Proposed Waitaha Hydro Scheme

PEER REVIEW

**APPLICANT'S ASSESSMENT OF NATURAL CHARACTER,
LANDSCAPE AND VISUAL AMENITY EFFECTS**

April 2015

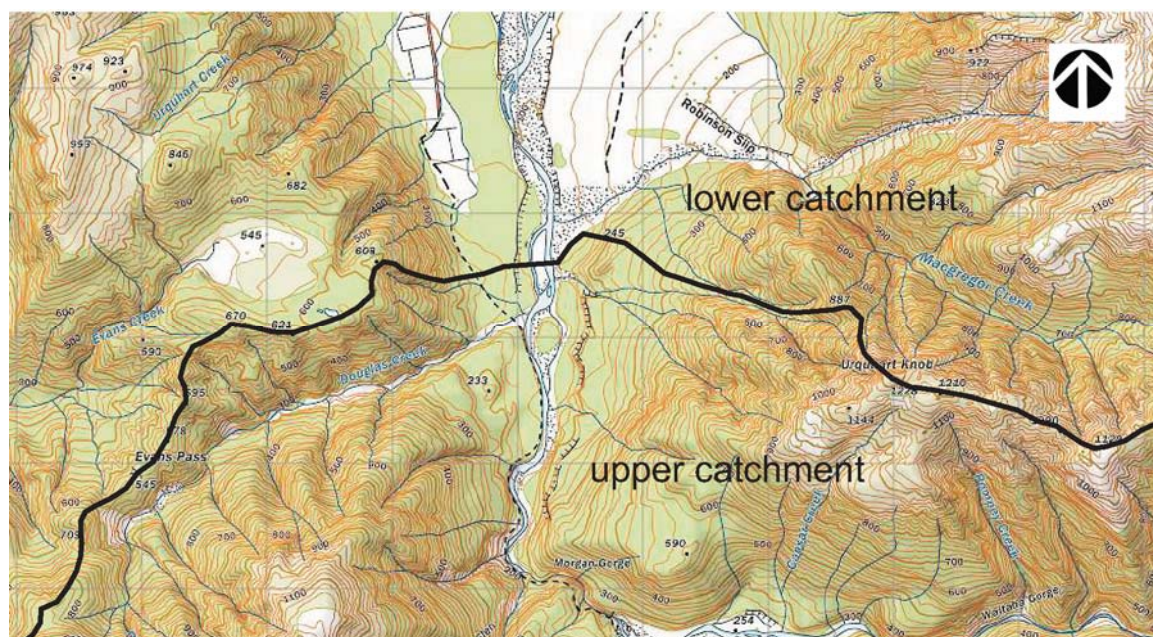
An issue raised in the Isthmus review argues that the line of demarcation between the upper and lower catchments could be mapped differently. Put simply, the upper catchment including the gorge is found by both Messrs. Lister and Bentley as likely to meet the requirements of an ONL, while the lower catchment is by contrast settled and farmed, and therefore less natural. The range pierced by the Morgan Gorge at a broad landscape scale provides the division between the two catchments and resulting different landscape character areas.

The Isthmus report suggests that the mapped line of change could be moved closer to the proposed powerstation site which infers that the more enclosed gorge

topography might be a better change point. However Mr Bentley has re-examined his assessment of this line and has decided to retain it as is⁴. I agree with Mr Bentley's opinion and I favour his more conservative approach. The landscape

Perhaps a third option for locating a catchment demarcation line would be to consider the Macgregor Creek sub-catchment as forming the boundary which would be topographically easy to define, and would still be close to Mr Bentley's Urquhart Knob spur division line (see diagram above).
